MIL-G-50680C (AR)
AMENDMENT 1
24 June 1991

MILITARY SPECIFICATION

GATE CIRCUITS, MULTIPLE BOARD ASSEMBLY - UPPER: 9342753

FIGURE 5. Board Assembly, upper test setup.

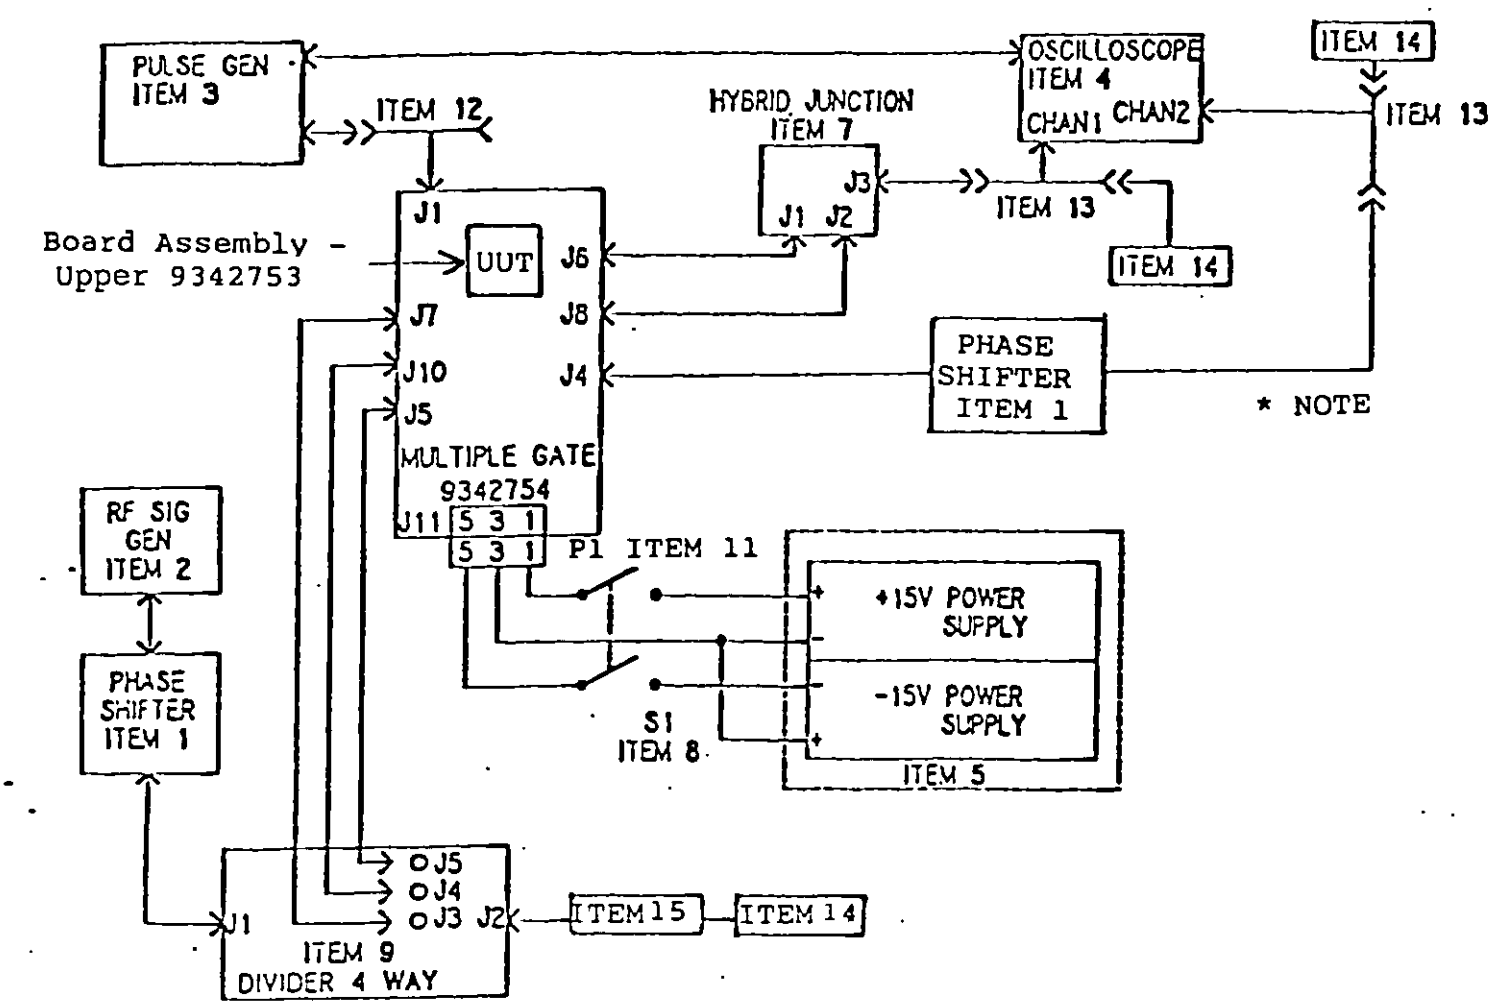
"3.5.2.3.4 Gate Noise. With the board assembly-upper connected with the test setup as shown in Figure 5, a 60± 1% MHz signal and a monitored 2.8 V p-p signal per gate applied to J5, J7 and J10 of the unit under test, the amplitude of the algebraic sum of the Early Gate and Sum Gate signals during the Early Gate period shall be less than 1.0 V p-p. The amplitude of the algebraic sum of the Late Gate and inverted Sum Gate signals during the Late Gate period shall be less than 1.0 V p-p."

Add Figure 5. enclosed (page 6A).

"4.7.3.4.4 Gate noise. Connect the unit under test to the test setup per Figure 5. Adjust channel 2 Phase Shifter so that the Early Gate on channel 1 is 180° out of phase with the Sum Gate on channel 2. Adjust variable gain on channel 2 for equal amplitude waveforms on channels 1 and 2. Place oscilloscope in channel 1 and 2 algebraic add function and readjust channel 2 phase shifter for Early Gate null. Resultant waveforms in the Early Gate shall be less than 1.0 V p-p. Place oscilloscope channel 2 in invert mode. Readjust amplitude and phase for Late Gate null. Resultant waveforms in the Late Gate shall be less than 1.0 V p-p."

Adjust Channel 2 Cable length as necessary to place Channel 1/ Channel 2 Waveform relationship into phase shifter adjustment range.
